Re: Data Request #8 for LS Power Grid California, LLC's Collinsville 500/230 Kilovolt Substation Project (A.24-07-018)

Project: LS Power Grid's Collinsville 500/230 kV Substation Project

Title: Data Request #8

Figure 1 Alternative 1

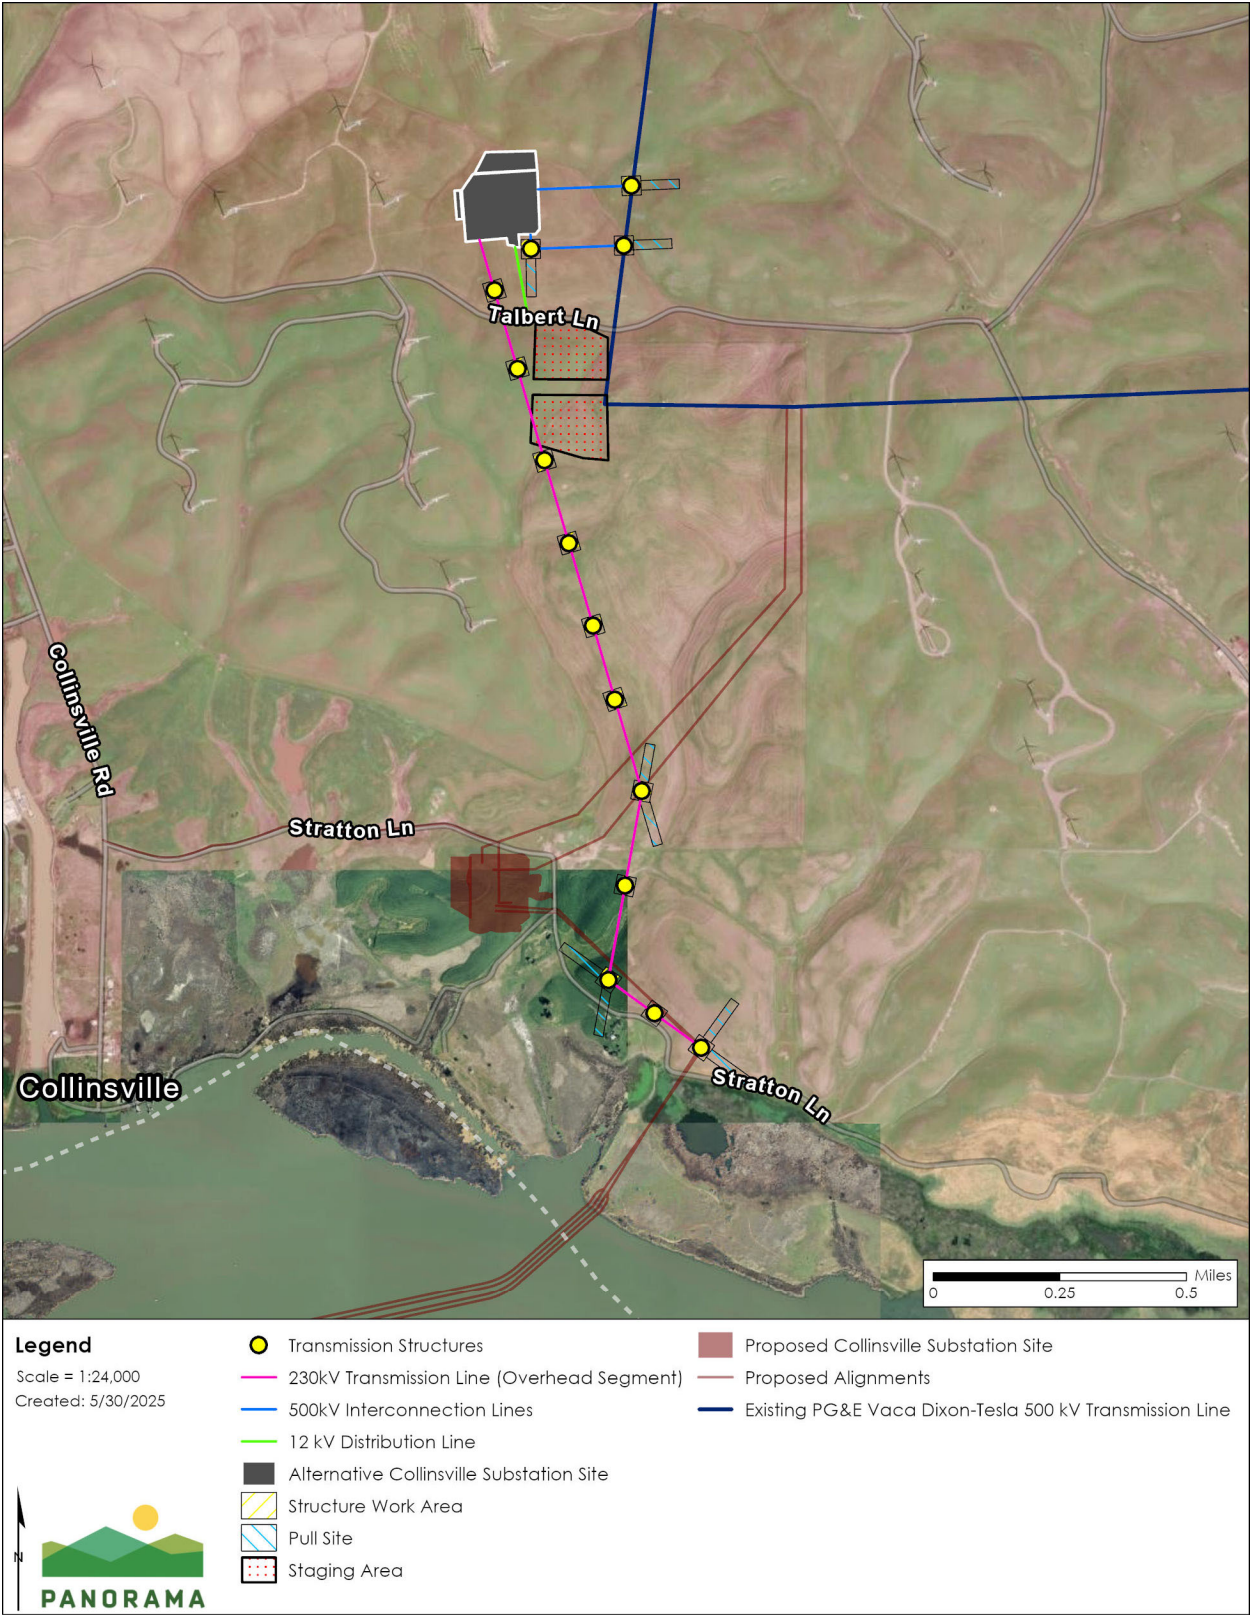
Section/Page Reference	CPUC Comment	Request ID	CPUC Request	LSPGC/PG&E Response
n/a	<p>DR-2: 12 kV Distribution Line for Alternatives 1 and 2</p> <p>The GIS data for Alternatives 1 and 2 include 12 kV distribution lines, but do not include structures for those lines.</p>	2	<p>Please clarify whether the 12 kV line shown in the GIS data for Alternatives 1 and 2 is an existing line or if it will be a newly constructed line. If it is new construction, please provide GIS data for the location of the support structures and confirm that wood poles would be used for the structures. If the 12kV distribution line would be buried please clarify the depth of burial and dimensions of the trench and provide a typical detail for the buried conduit.</p>	
n/a	<p>DR-3: Access Roads for Alternatives 1, 2, and 4</p> <p>The GIS data for Alternative 1 (substation site north of Talbert Lane), Alternative 2 (substation site east of wind energy substations), and Alternative 4 (230 kV overhead segment alternative route on PG&E property) show access roads servicing the 230 kV overhead line and other project elements, but there is no information about whether these roads are existing or new construction or whether they will be temporary or permanent access roads. This matters when it comes to environmental impacts because, per the Project Description, the impact areas are different depending on the type of road, i.e., the road width for existing unpaved roads is 36 feet while the road width for new temporary access roads is 16 feet.</p>	3	<p>Please provide GIS data that clarifies the type of roads that will be used for access to the project elements for Alternatives 1, 2, and 4. In the GIS data, please include whether the road is (1) an existing road vs new construction and (2) temporary or permanent.</p> <p>Please also confirm that the road widths are 36 feet for existing unpaved roads and 16 feet for new temporary roads. Also include widths for any other types of access roads that may be used in the alternatives.</p> <p>Please complete Table 1 provided on the following page for Alternative 1 (substation site north of Talbert Lane), Alternative 2 (substation site east of wind energy substations), and Alternative 4 (230 kV overhead segment alternative route on PG&E property) separately. We will need separate analysis of each alternative requiring separate details on access roads for each alternative.</p>

Section/Page Reference	CPUC Comment	Request ID	CPUC Request	LSPGC/PG&E Response
n/a	<p>DR-4: Alternative 1 and Alternative 2 Substations 500 kV Interconnection Line Structures</p> <p>The GIS data provided appears to show one 500 kV interconnection LST just south of the Alternative 1 substation and no structures for the northern line within the substation or adjacent the substation (see Figure 1 below). Where would the northern line tie into the substation? Would the southern 500 kV LST be a transition structure or a separate LST with a separate transition structure located within the substation?</p> <p>The GIS data provided appears to show one 500 kV interconnection LST just north of the Alternative 2 substation and no structures for the southern line within or adjacent the substation (See Figure 2 below). Where would the southern line tie into the substation? Would the northern 500 kV LST be a transition structure or a separate LST with a separate transition structure located within the substation?</p>	4	Please review the Figures for Alternative 1 and Alternative 2 below and provide updated GIS data that reflects the location of the structures for the northern and southern 500 kV interconnection lines for each alternative respectively. Please also clarify if the poles for the 500 kV interconnection lines in each case would be LSTs or TSPs.
